16 April 2021

BASEMENT REDESIGN MODIFICATION 4 SEDIMENT REDISTRIBUTION SUBMISSION TO DPIE - MARITIME HERITAGE – SSDA 8925

Figure 1: Revised location for test trenches shown in green

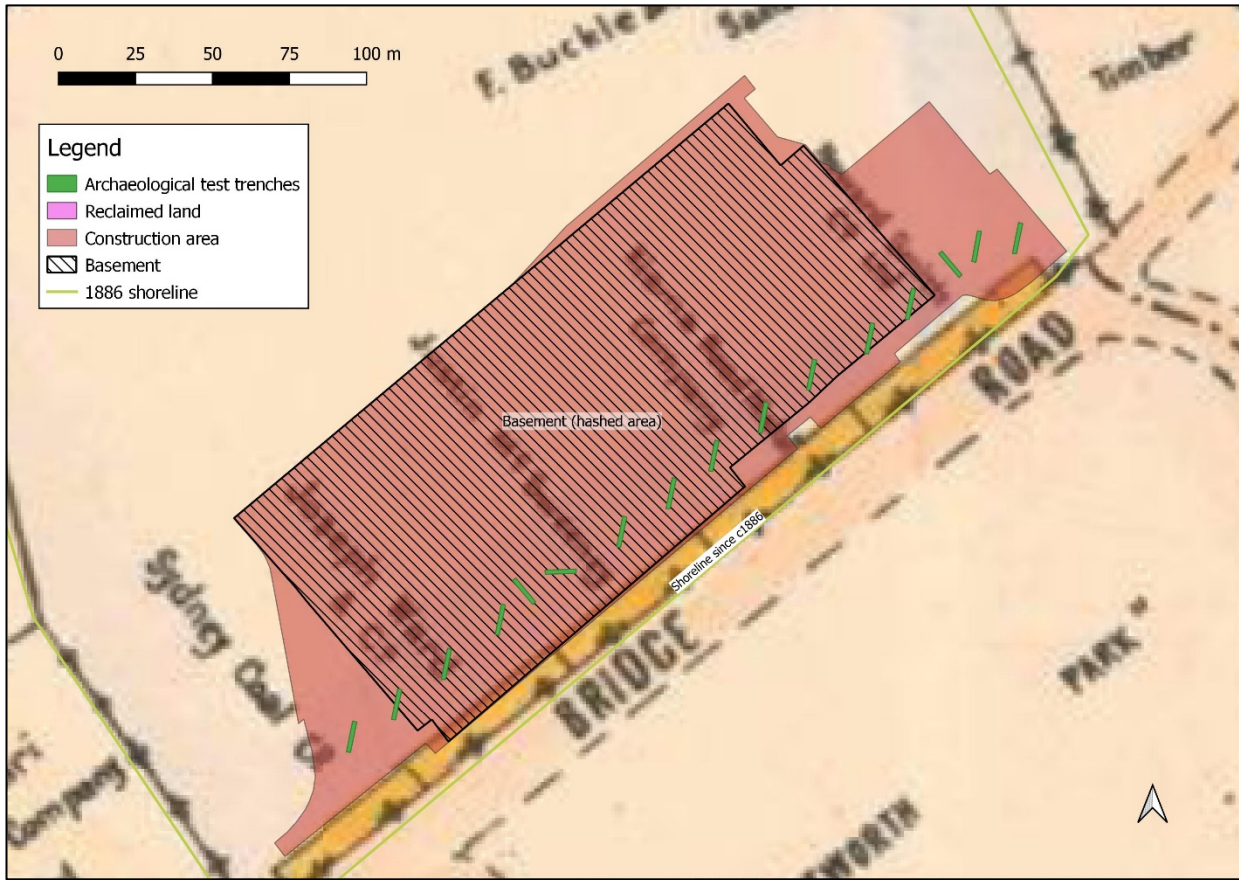
- To mitigate impacts, the following adjustments to the archaeological testing program are recommended:
 1. Two additional archaeological test trenches should be placed in the area that lay beneath the Hanson Concrete Dispatching Plant wharf. This is an area where new piling will be taking place for the Western Plaza.

2. The proposed placement of the test trenches on the eastern side of the new Sydney Fish Market be revised to enable testing in the area to be occupied by the Eastern Plaza.

The recommended revised test trench plan is shown in the attached overlays where the trenches have been placed over a georeferenced 1908 map of the area (Figure 1). This map shows the relationship of the test trenches to the 1886 shoreline, the 1908 industries at the wharves, the construction area of the new Sydney Fish Market and also the basement area.
